SERVICE BULLETIN

N° **139-694**

ATA 56 – WINDOW GASKET UPGRADE

This Service Bulletin is issued in order to provide the necessary instructions to introduce a new gasket installation on the basic jettisonable emergency exit of the helicopter .

Figure 1

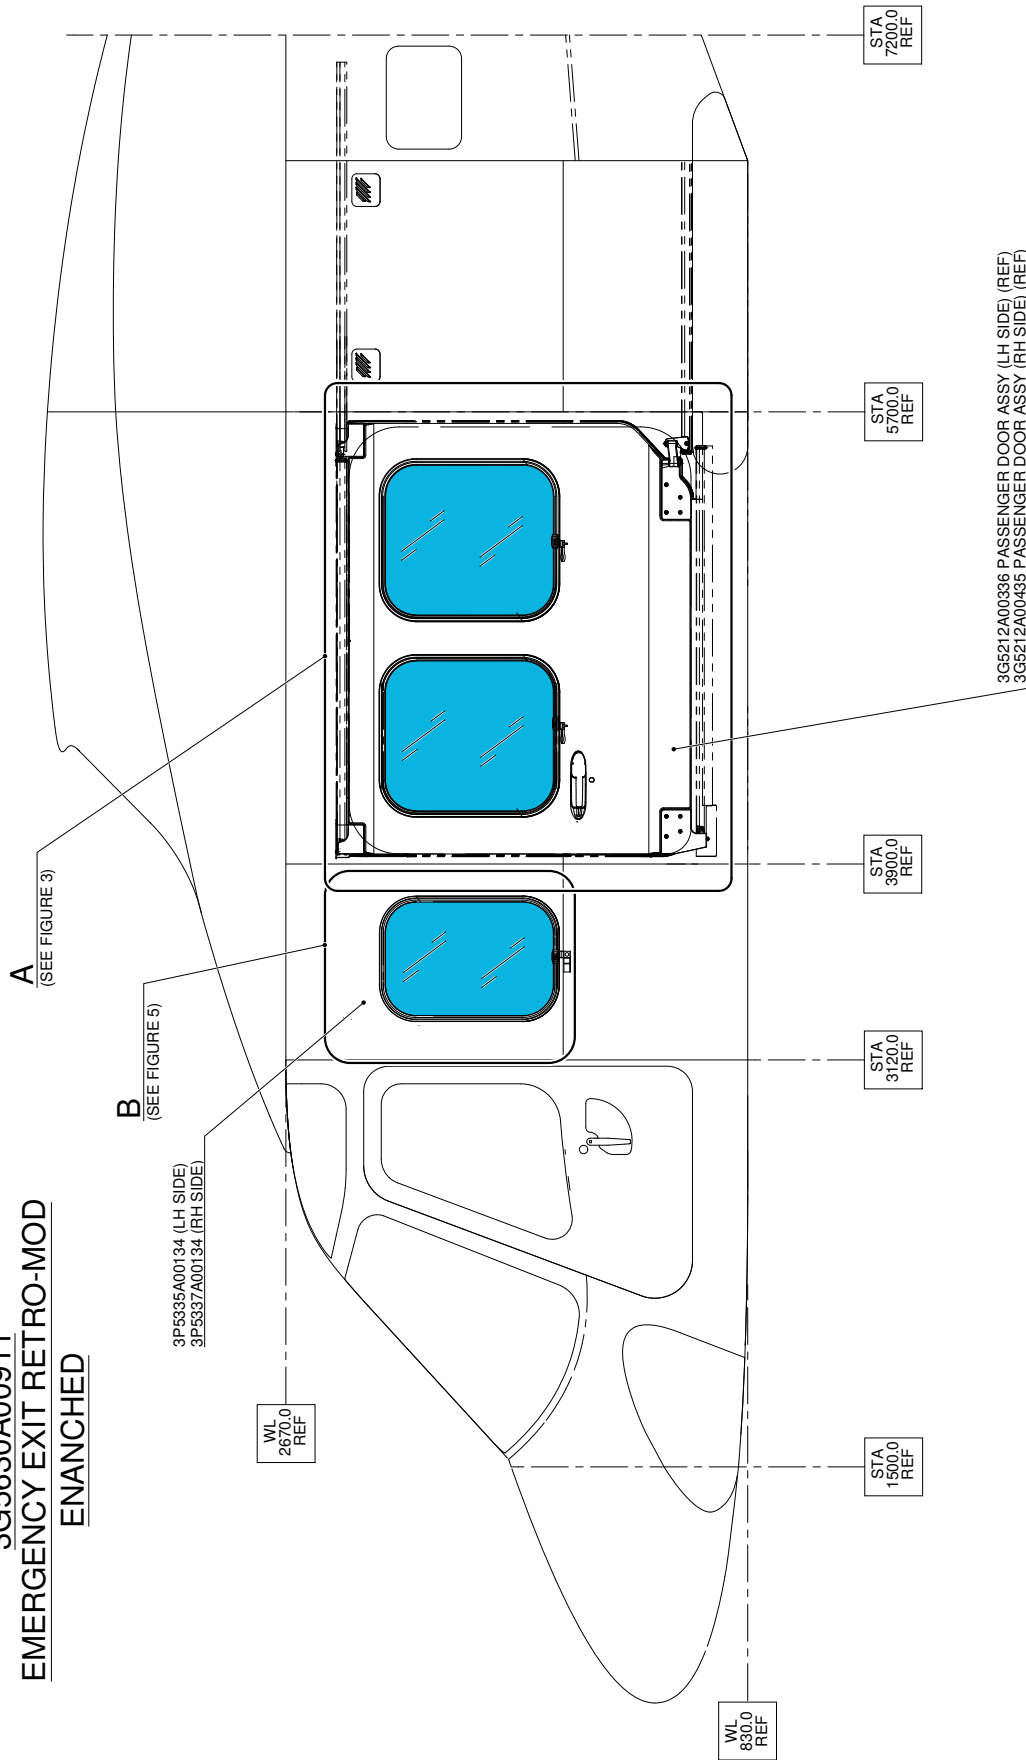
For the emergency exit window retromod P/N 3G5600P00911 refer to Figure 1 and Figures 3 thru 6.

2. In accordance with the applicable steps of AMP DM 39-A-56-21-01-00A-920A-A and with reference to Figures 1 or 2 and Figure 5 Detail B, from the left side wall assy, remove the existing window panel (retain for later reuse), extd rubber window seal P/N A417AG002WB, n°2 extd rubber fillers P/N A417AF001WB, strap assembly P/N A487A005A and stud P/N MS27980-13N.

3. In accordance with the applicable steps of AMP DM 39-A-56-32-01-00A-920A-A and with reference to Figures 1 or 2 and Figure 3 Detail A, from the left cabin sliding door assy, remove n°2 existing passenger door windows (retain for later reuse), n°2 extd rubber window seals P/N A417AG002WB2412, n°4 extd rubber fillers P/N A417AF001WB2412, n°2 strap assemblies P/N A487A003A and n°2 studs P/N MS27980-13N.

- 6.1 In accordance with the applicable steps of AMP DM 39-A-56-21-01-00A-920A-A and with reference to Figures 1 or 2 and Figures 5 and 6, install the following components on the left side wall assy:

Figure 2

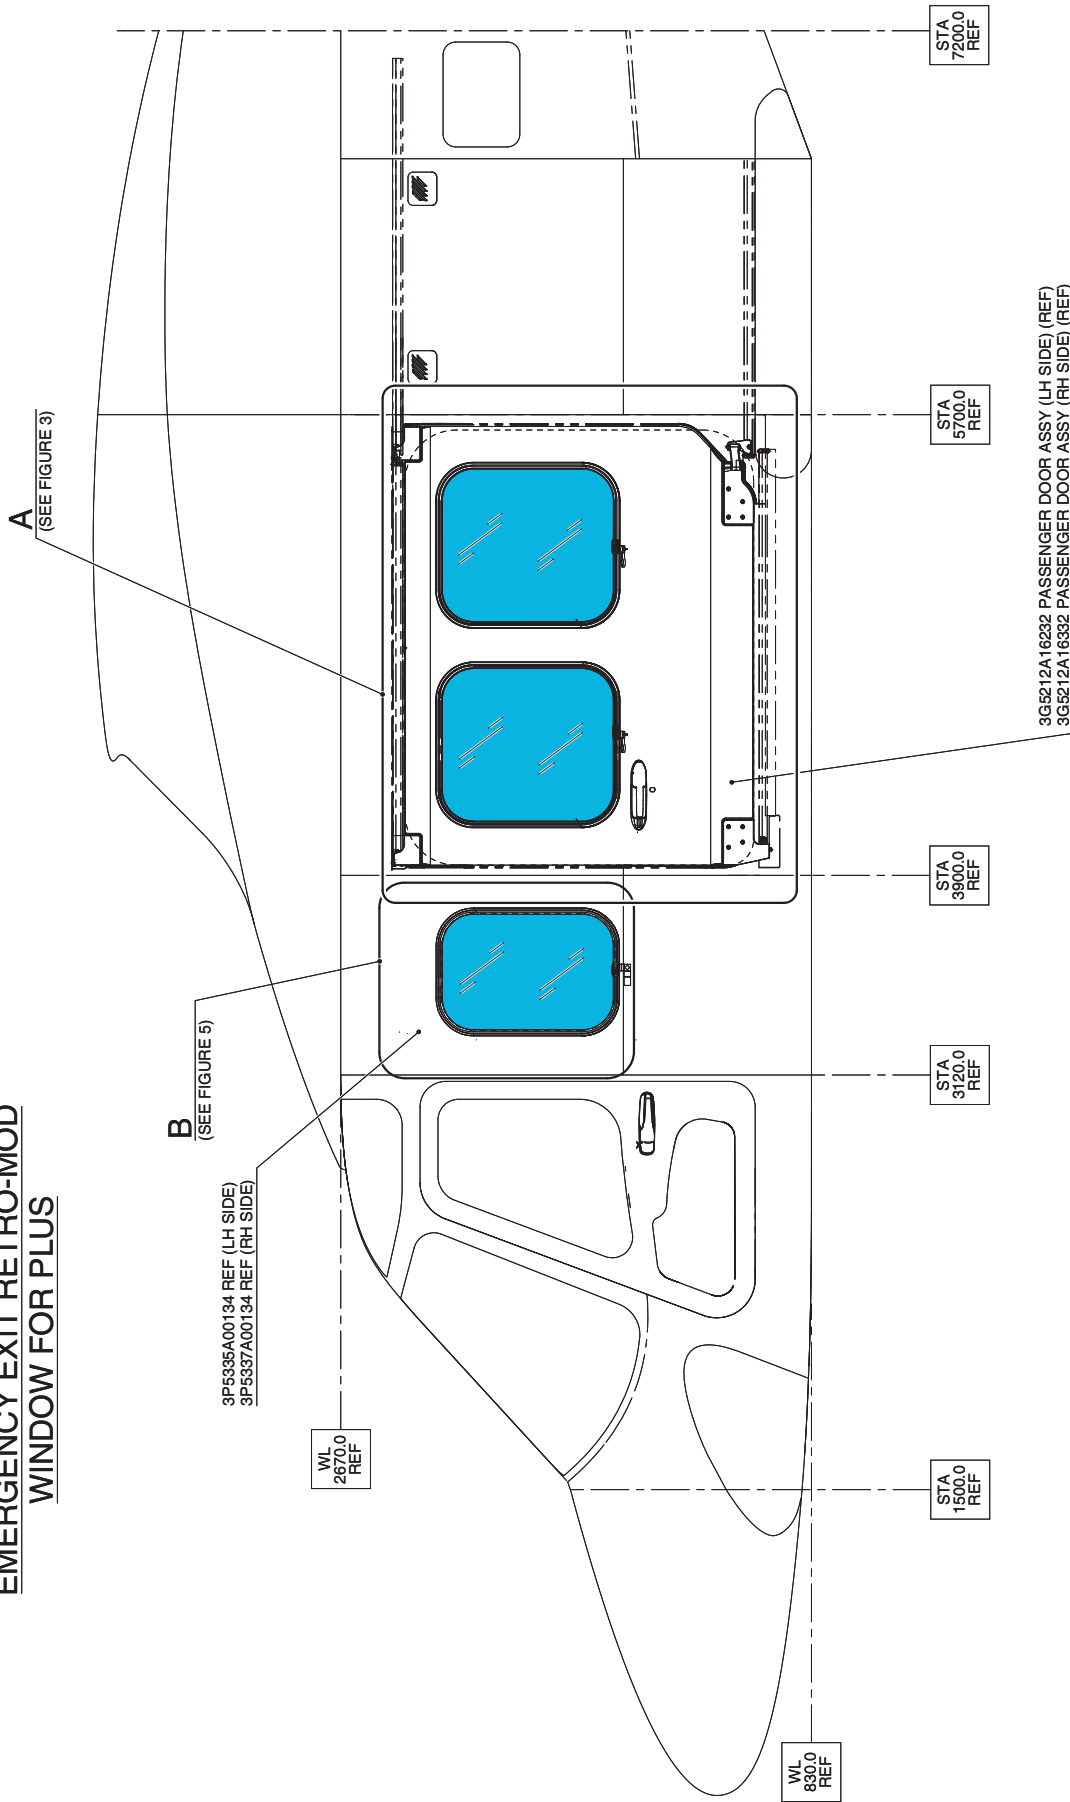
For the emergency exit window retromod P/N 3G5600P01011 refer to Figure 2 and Figures 3 thru 6.

Figure 3

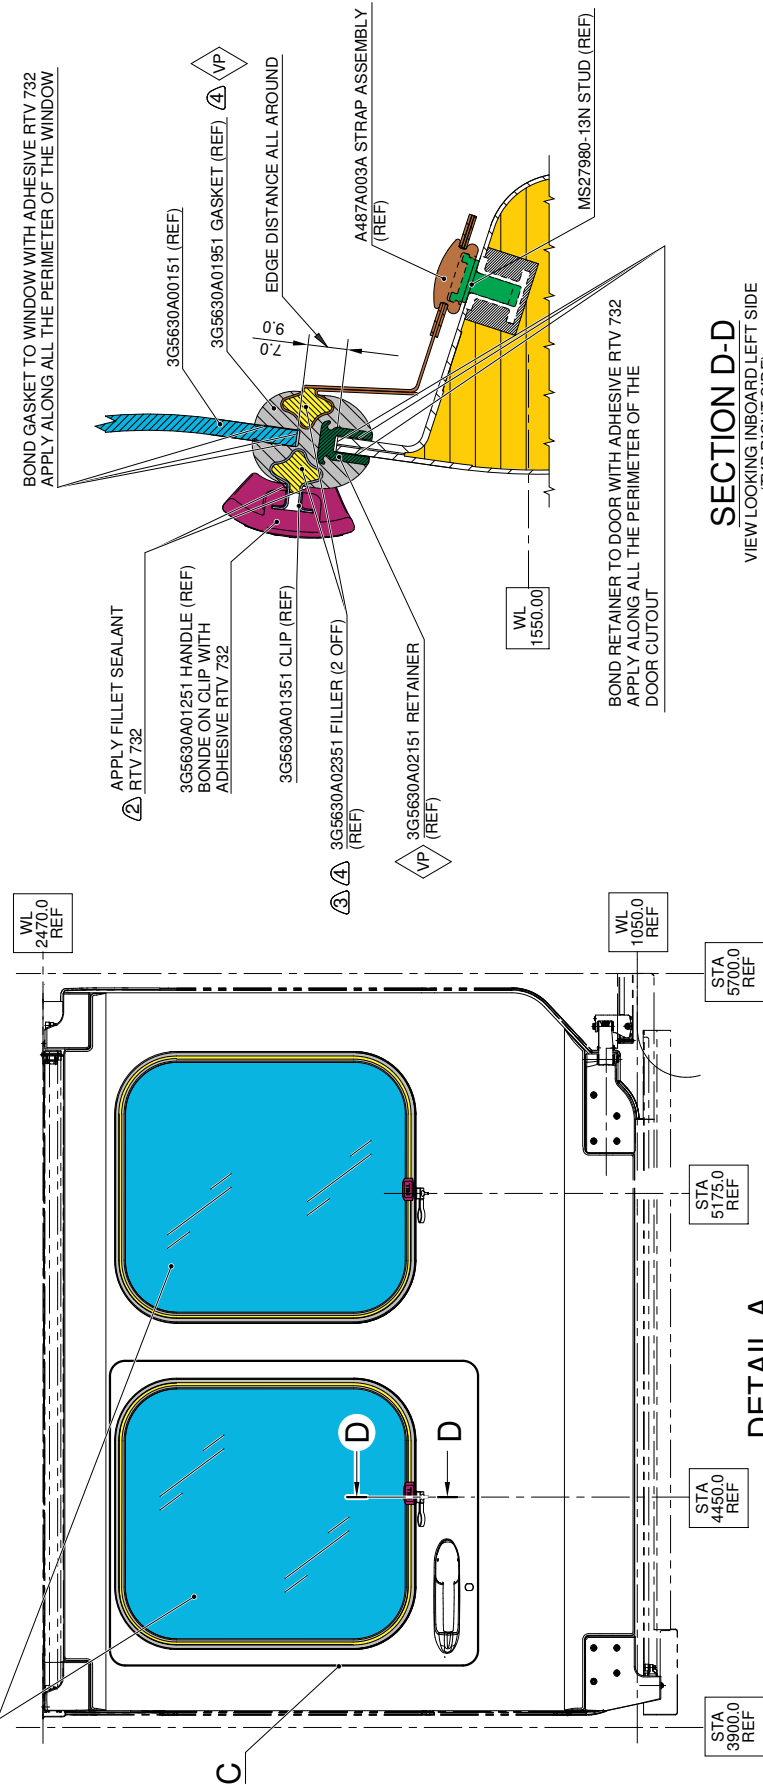
- REMOVE:**
- ① 3G5630A00151 PASSENGER DOOR WINDOW (2 OFF)
 - A417AG002WB2412 EXT.D. RUBBER WINDOW SEAL (2 OFF)
 - A417AF001WB2412EXTD. RUBBER FILLER (4 OFF)
 - A487A003A STRAP ASSEMBLY (2 OFF)
 - MS27980-13N STUD (2 OFF)
- INSTALL:**
- ① 3G5630A00151 PASSENGER DOOR WINDOW (2 OFF) (REF)
 - 3G5630A01951 GASKET (2 OFF)
 - 3G5630A02351 FILLER (4 OFF)
 - 3G5630A02151 RETAINER (2 OFF)
 - 3G5630A02051 RETAINER (2 OFF)
 - 3G5630A02251 RETAINER (4 OFF)
 - A487A003A STRAP ASSEMBLY (2 OFF)
 - MS27980-13N STUD (2 OFF)
 - 3G5630A01251 HANDLE (2 OFF)
 - 3G5630A01351 CLIP (2 OFF)

- ① THE WINDOW PANEL MAY BE SLIGHTLY DIFFERENT FROM THAT SHOWN.
- ② APPLY THE FILLET SEALANT ONLY AFTER INSTALLING THE CLIP P/N 3G5630A01351 AND FILLER (P/N 3G5630A02351 AND P/N 3G5630A02951) IN THE GASKET SEAT. THE FILLET SEALANT MUST BE AS LONG AS THE CLIP TO PREVENT THE SQUEEZE OUT GOING ON FILLER INSIDE THE GASKET SEAT.
- ③ ON INTERNAL FUSELAGE SIDE INSTALL FILLER STARTING FROM TOP SIDE OF FRAME WINDOW.
- ④ ON EXTERNAL FUSELAGE SIDE:
 - INSTALL FILLER STARTING FROM TOP SIDE OF FRAME WINDOW;
 - CHECK IF THERE IS SQUEEZE OUT OF ADHESIVE ALL AROUND THE GASKET, IF NOT, LIFT THE SEAL EDGE AND FILL AGAIN.

- the stud P/N MS27980-13N.
- 6.2 In accordance with the applicable steps of AMP DM 39-A-56-32-01-00A-920A-A and with reference to Figures 1 or 2 and Figures 3 and 4, install the following components on the left cabin sliding door assy:

Figure 5

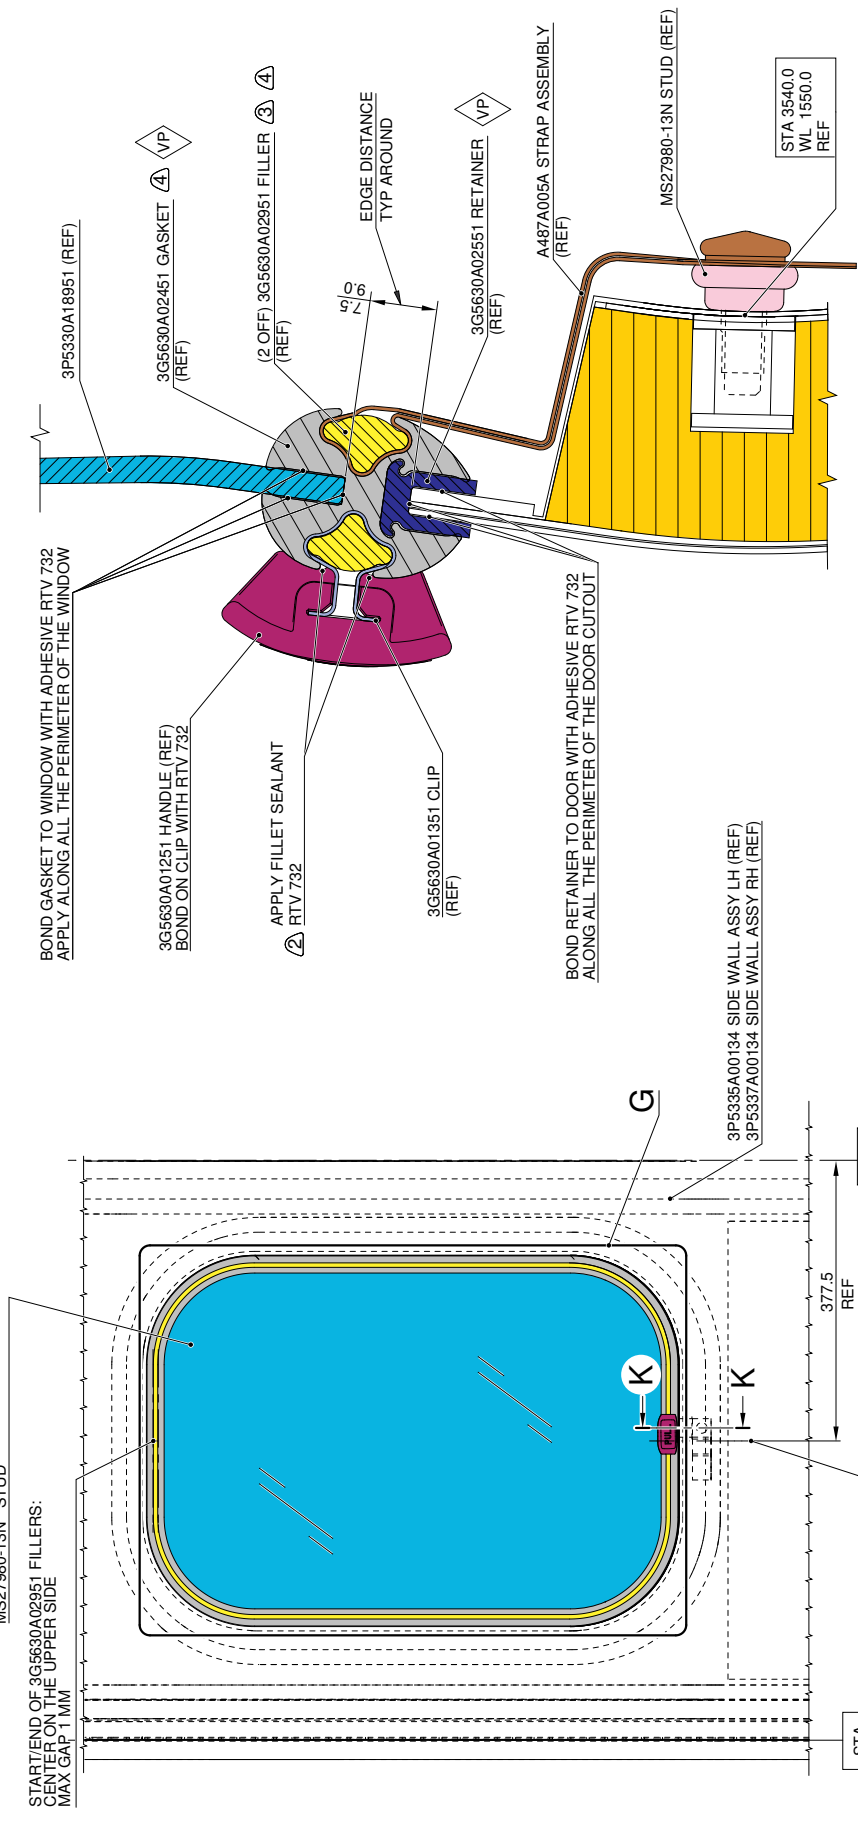
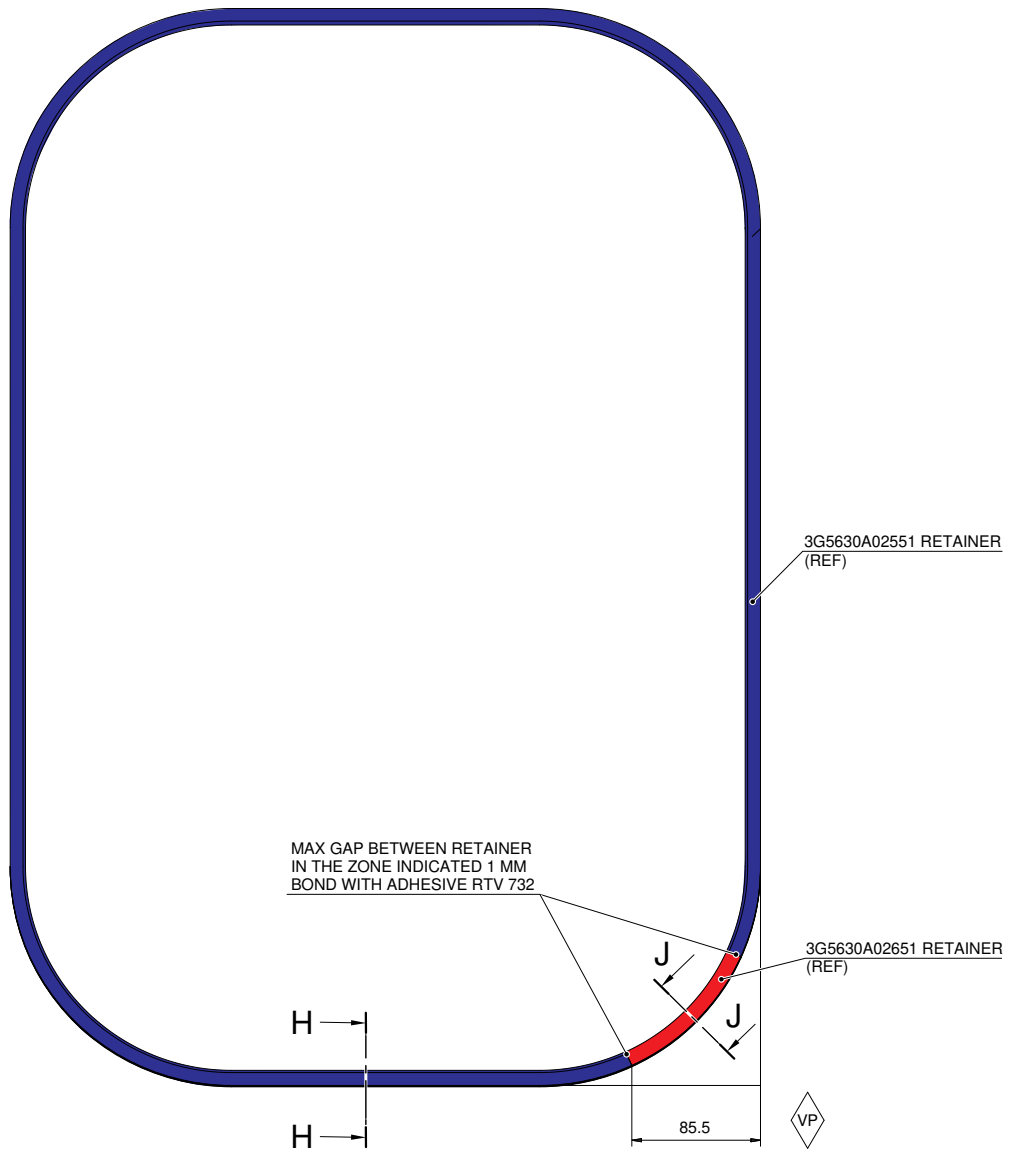
- REMOVE:**
- 3P5330A18951 WINDOW PANEL
 - A417AG002WB EXTD. RUBBER WINDOW SEAL
 - A417AF001WB EXTD. RUBBER FILLER (2 OFF)
 - A487A005A STRAP ASSEMBLY
 - MS27980-13N STUD

- INSTALL:**
- 3P5330A18951 WINDOW PANEL (REF)
 - 3G5630A02551 RETAINER
 - 3G5630A02651 GASKET
 - 3G5630A02451 FILLER (2 OFF)
 - 3G5630A01251 HANDLE
 - 3G5630A01351 CLIP

Figure 7

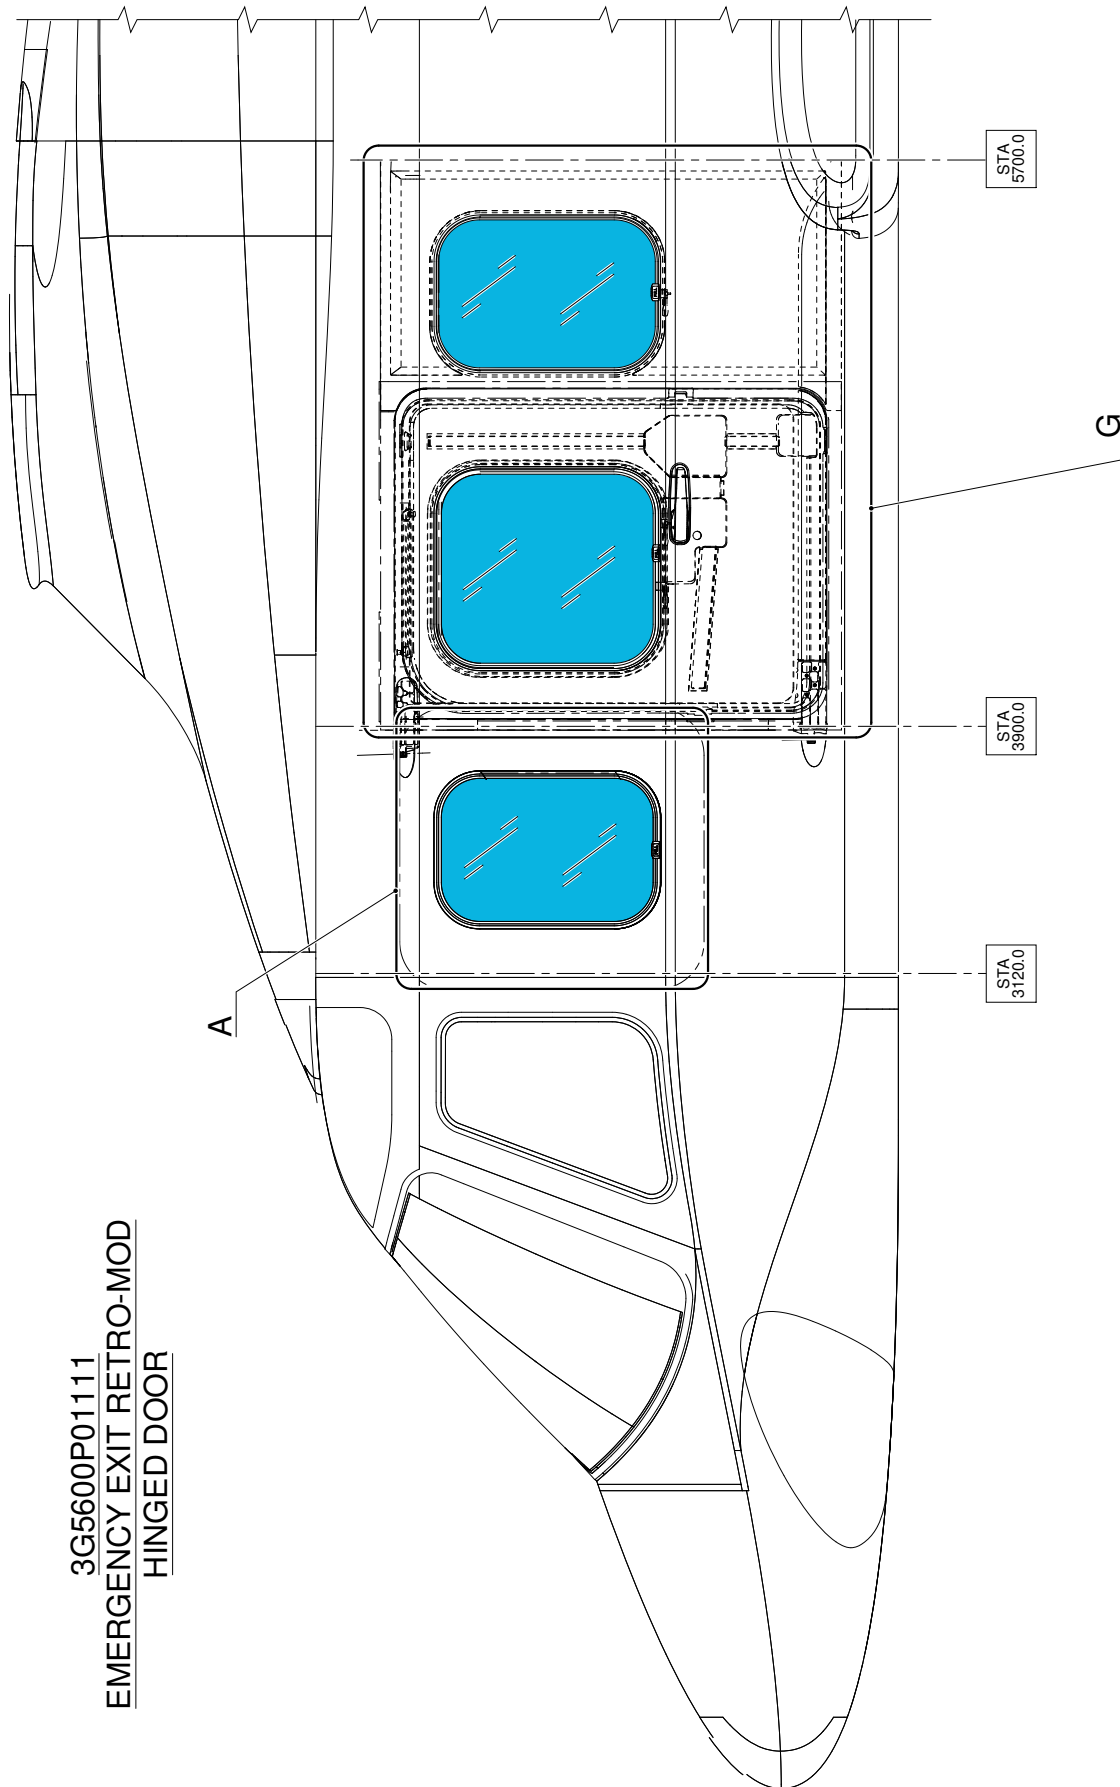
2. In accordance with the applicable steps of AMP DM 39-A-56-21-01-00A-920A-A and with reference to Figures 7 and 8 Detail A, from the left side wall assy, remove the existing window panel (retain for later reuse), extd rubber window seal P/N A417AG002WB, n°2 extd rubber fillers P/N A417AF001WB, strap assembly P/N A487A005A and stud P/N MS27980-13N.

3. In accordance with the applicable steps of AMP DM 39-A-56-21-01-00A-920A-A and with reference to Figures 7 and 11 Detail G, from the left fixed door assy, remove the existing window panel (retain for later reuse), window seal profile P/N 3P5330A19852, n°2 window seal wedge P/N 3P5330A19952, strap assembly P/N A487A003A and stud P/N MS27980-13N.

8. With reference to Figures 7 thru 14, perform the installation of the new cabin window gaskets as described in the following procedure:
